Office Action Summary	Application No. 10/613,510	Applicant(s) PURVIS ET AL.	
	Examiner Chi Q. Nguyen	Art Unit 3635

DETAILED ACTION

FIG. 5.

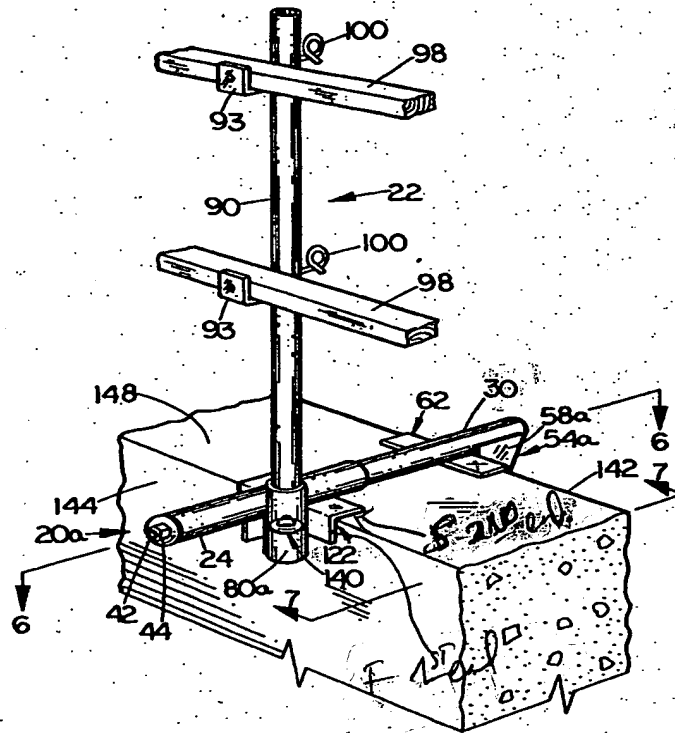
In regard claim 15, McLaughlin teaches a gable post support comprising a body 122 having a first end F (see attached figure 5), a post receiver 80a carried by said body 122, and a stabilizer 30 carried by a second end S of the body (see figures 5-6).

In regard claim 18, McLaughlin teaches the claimed invention as stated, wherein said stabilizer comprises an elongate stabilizer receiver 30, and a stabilizer receiver 24 connected to said body 122 (see figure 5).
